**Teeple Architects INC.**

Reviewed (✓)  
 Reviewed as noted (✓)  
 Revise and resubmit ( )  
 Not Reviewed ( )  
 Date: 2015.05.23  
 Reviewed by: [Signature]

SQ ALEXANDRIA PARK  
 BLOCK 11  
 TORONTO, ONTARIO  
 ELEVATORS No. 1 to 3  
**PIT PLAN**

'b'	PIT LADDER SIZE & LOCATION REVISED. GOVERNOR TENSION MOTOR H.P. ALL REVISED IN ELEVATOR DATA.	W.T.	03/08/15
'a'	DIMENSIONS TO COLUMN LINES REVISED. LAYOUT APPROVED AND MADE FINAL.	W.T.	12/27/14
No.	REVISION	BY	DATE
BLDG. NAME	SQ ALEXANDRIA PARK - BLOCK 11		
ADDRESS	TORONTO, ONT.		
	THREE (3) GEARED PASSENGER ELEVATORS		
	<b>SELCO ELEVATORS LTD.</b>		
DRWG. No.	SQ ALEX PARK	REV. 'B'	SHEET 1 of 8

HALL ENTRANCE ASSEMBLY-SINGLE SPEED 42"x84" OPNG.

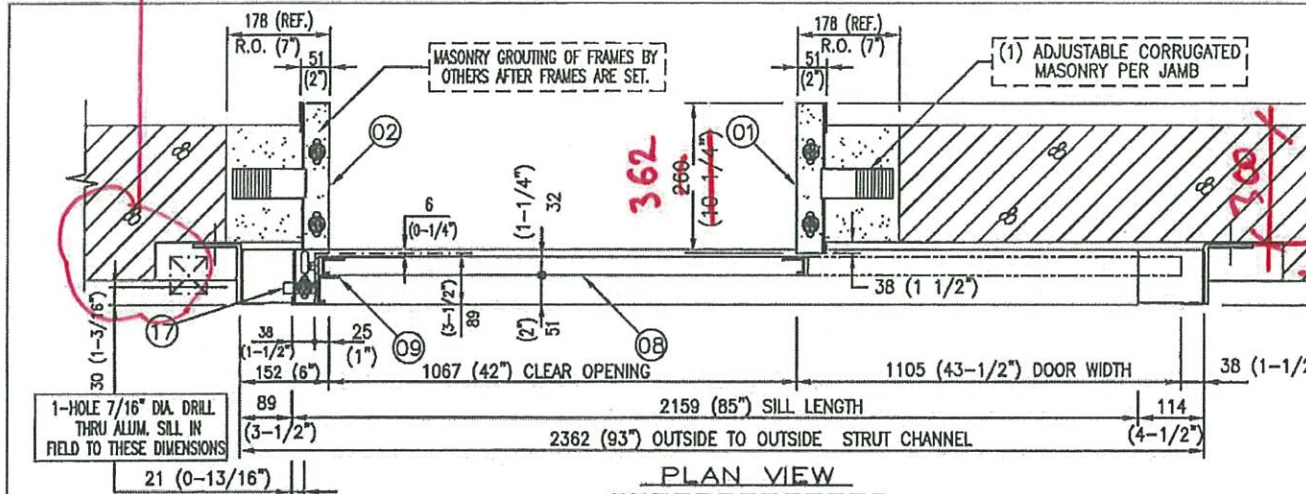
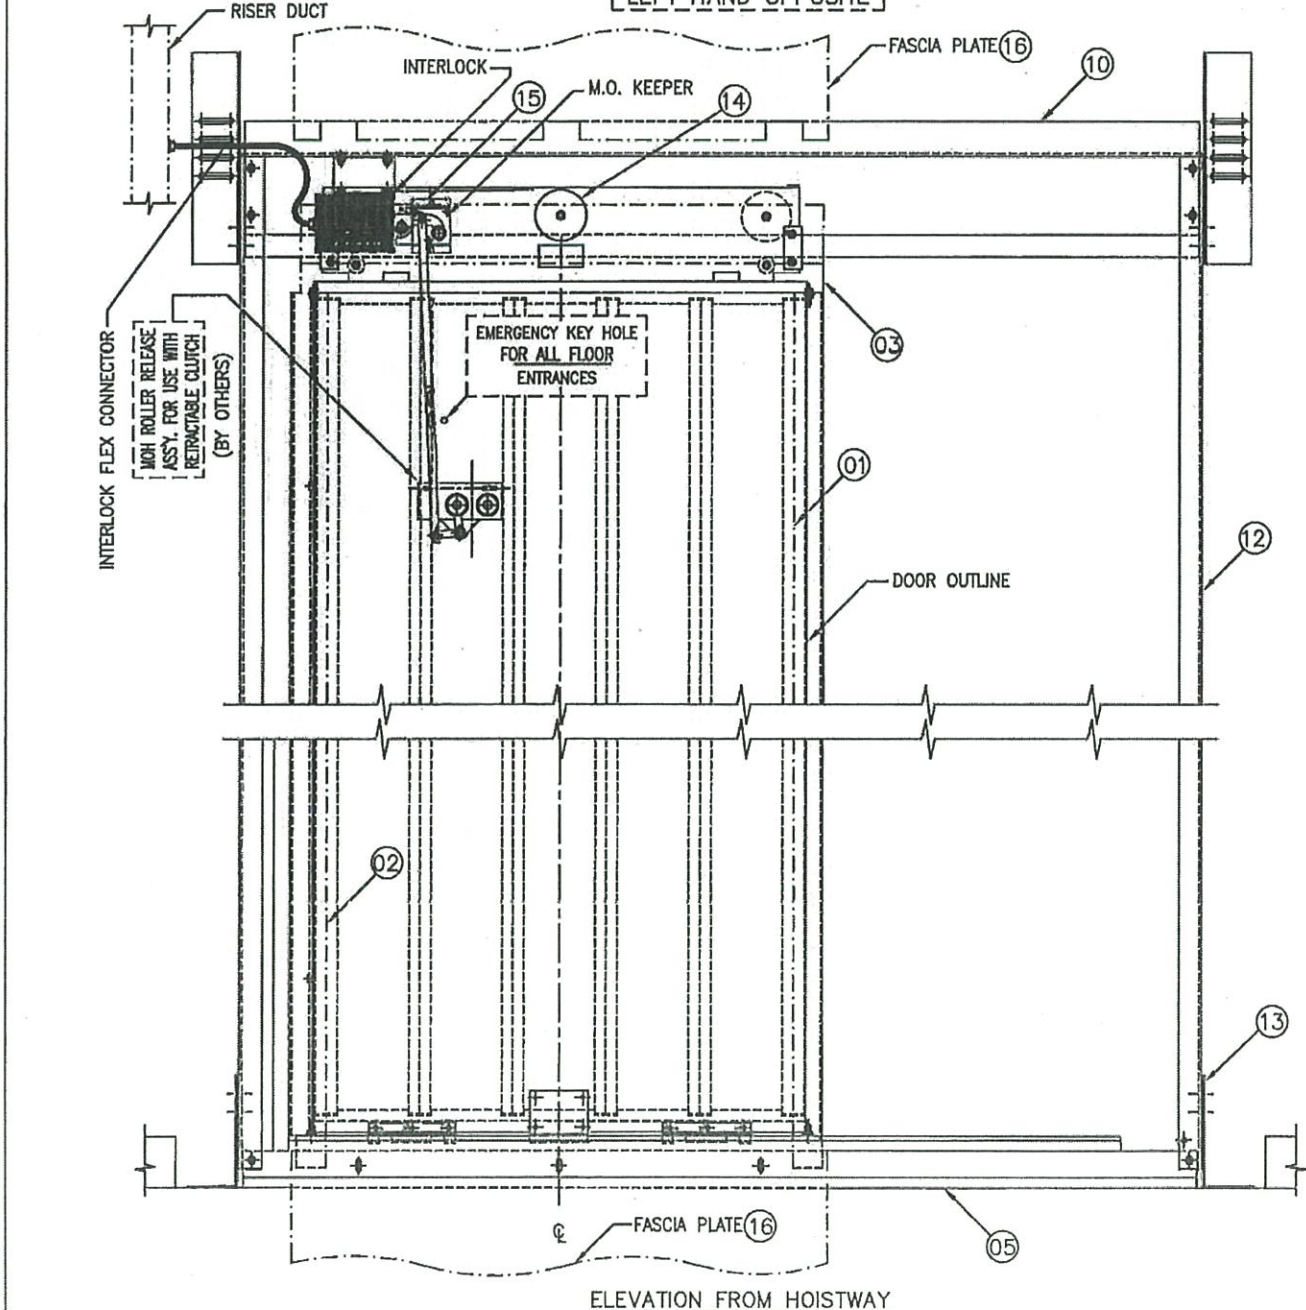
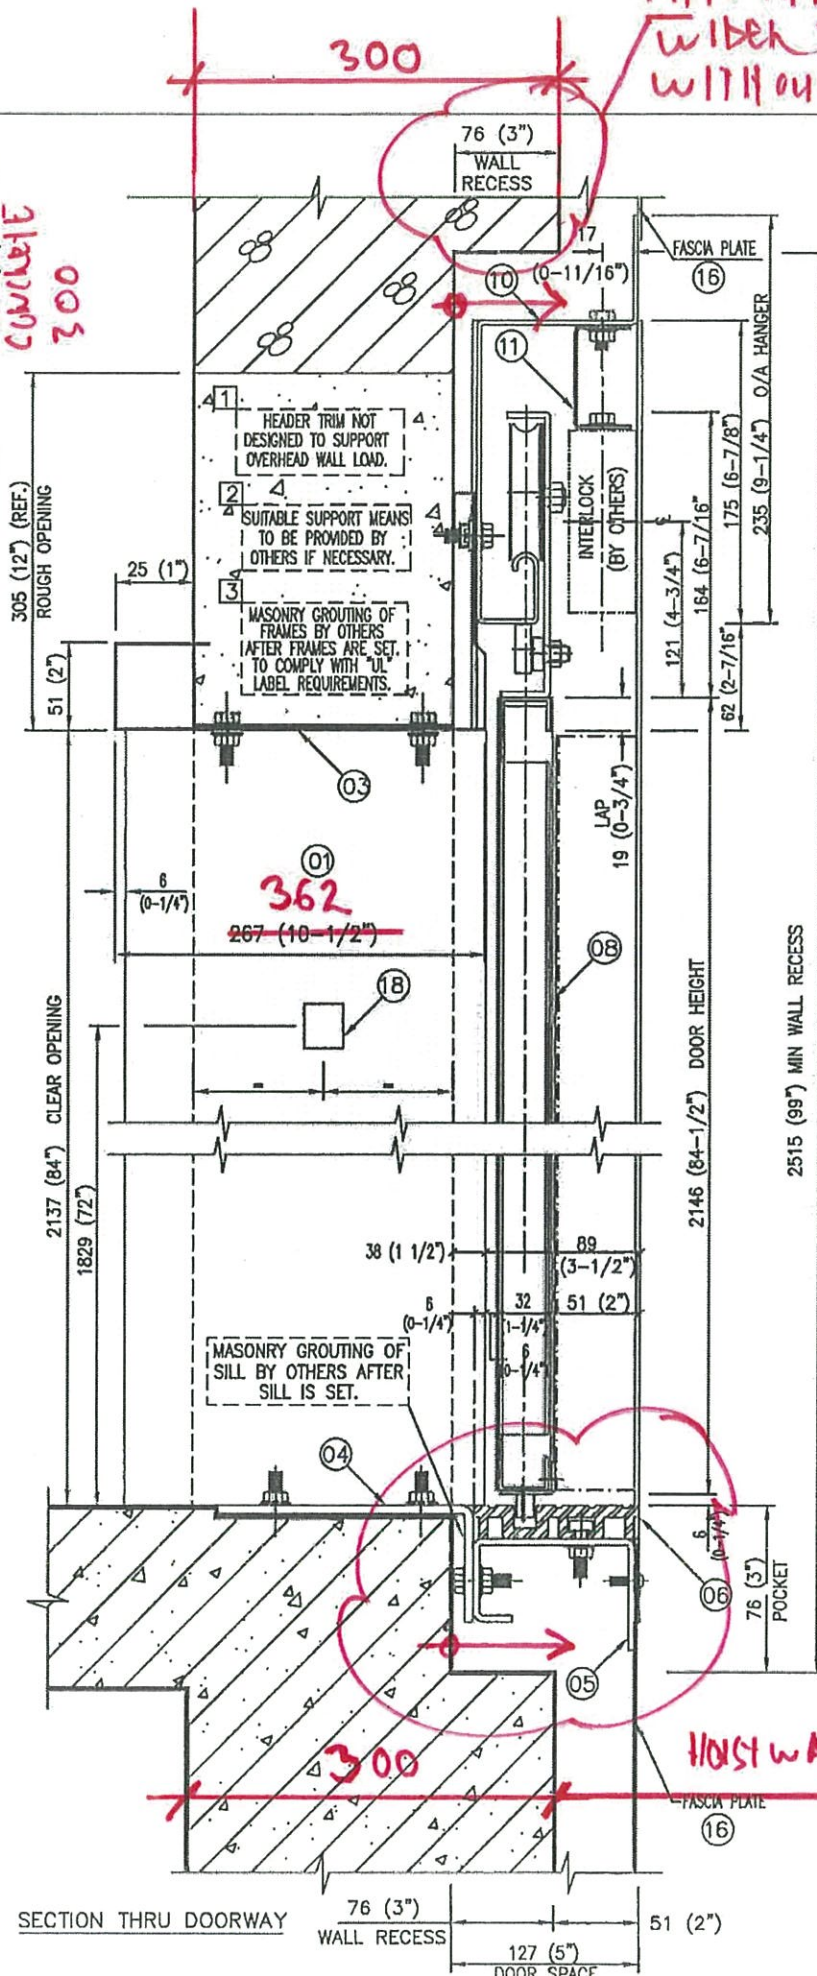
NO RECESS AT REAR DOORS.

PIT SHAFT FROM P2 TO LEVEL 2 W/S. 70 mm. WIDER TO ACCOMMODATE HOISTWAY DOOR WITHOUT RECESS. SEE ARCHITECTURAL & SELCO SHOPS.

HOISTWAY 2070 SEE SELCO SHEET 7 OF 8

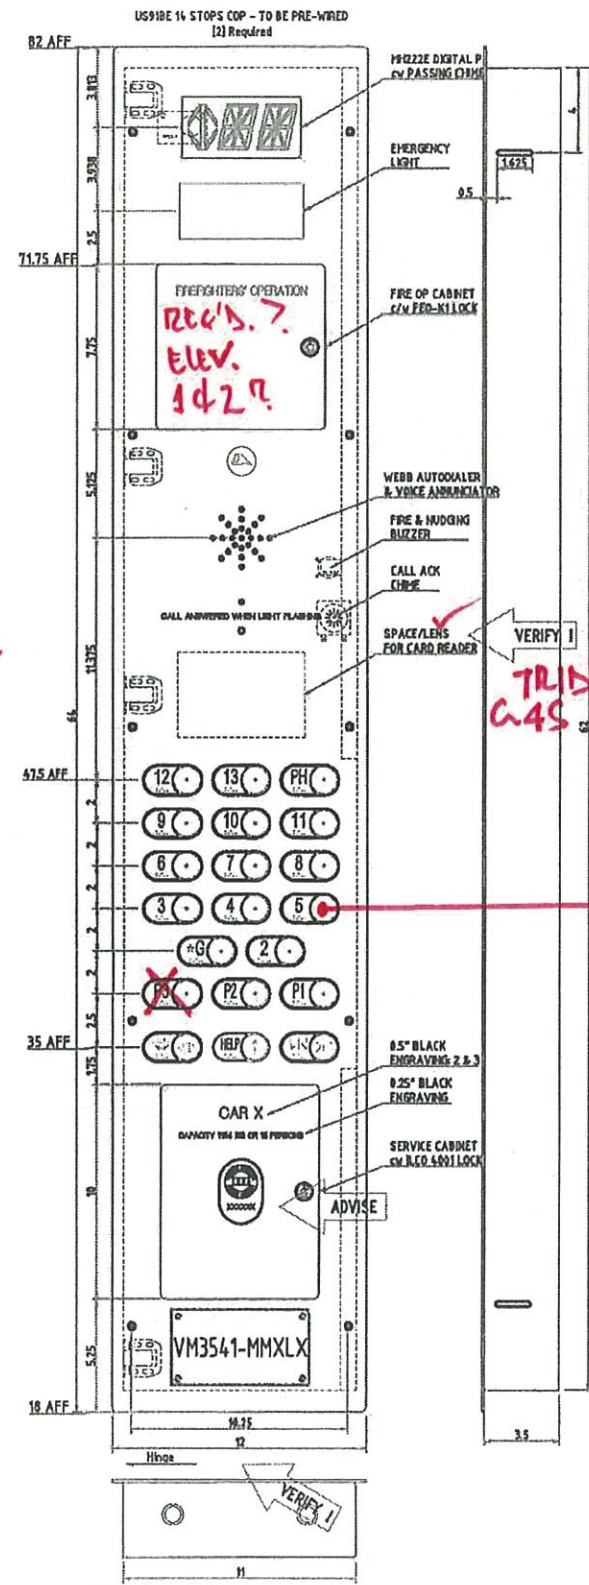
ELEV 3 IS FIREFIGHTERS

THIBEL / C.45 NOTE

PROVIDE SAMPLE

NO P3

INTERIOR TO CONFIRM

ELEV 3. ONLY?

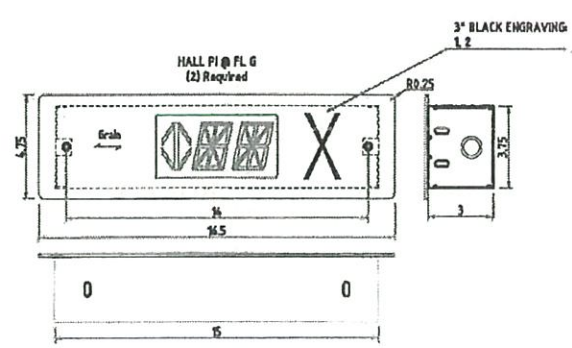
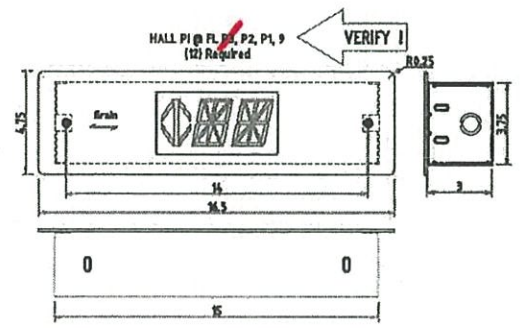
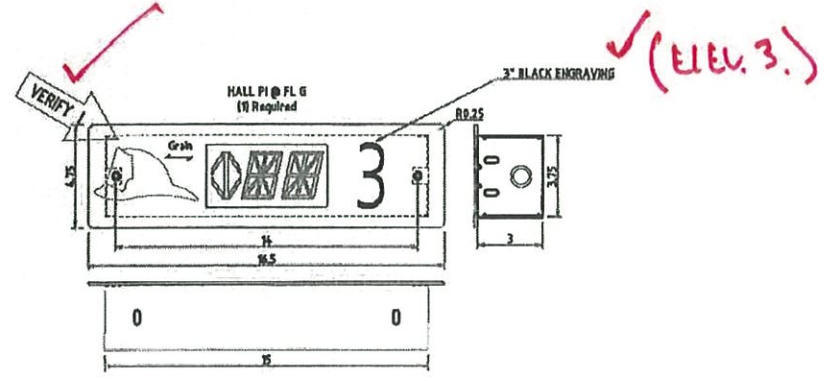
VERIFY I

INTERIORS?

ELLV.3

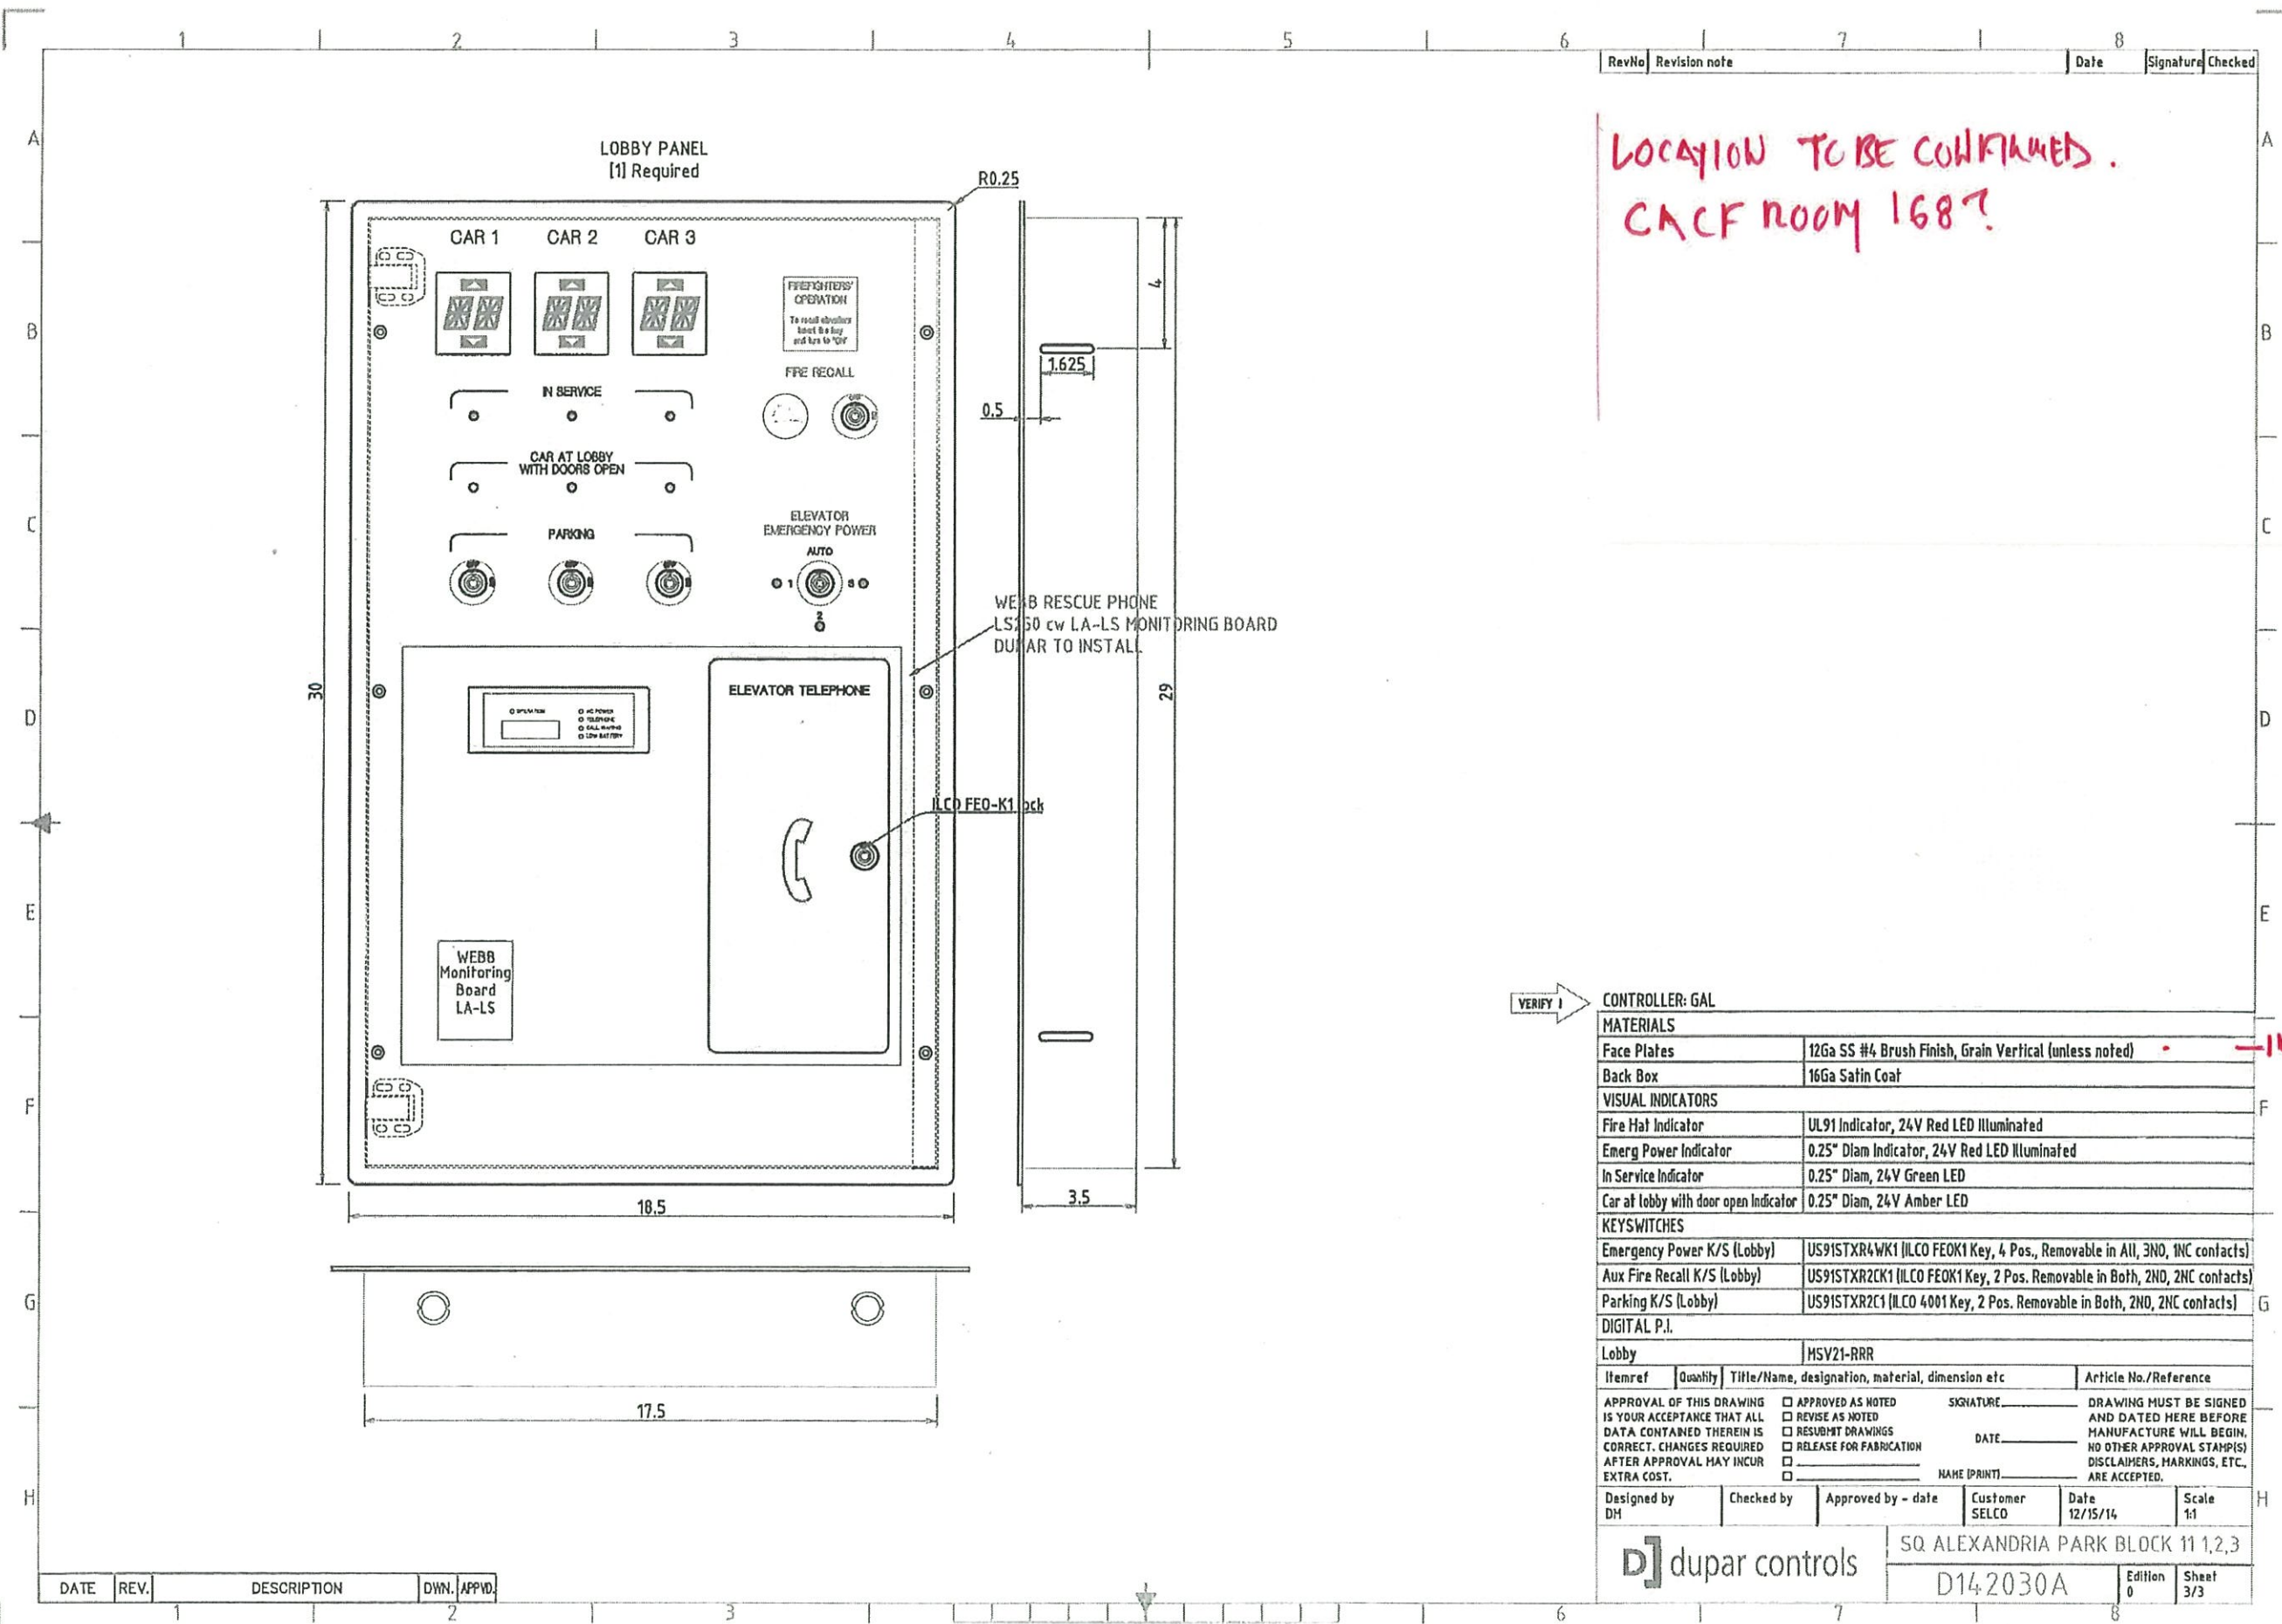
LOCATION TO BE CONFIRMED.  
CACF ROOM 168?

VERIFY I
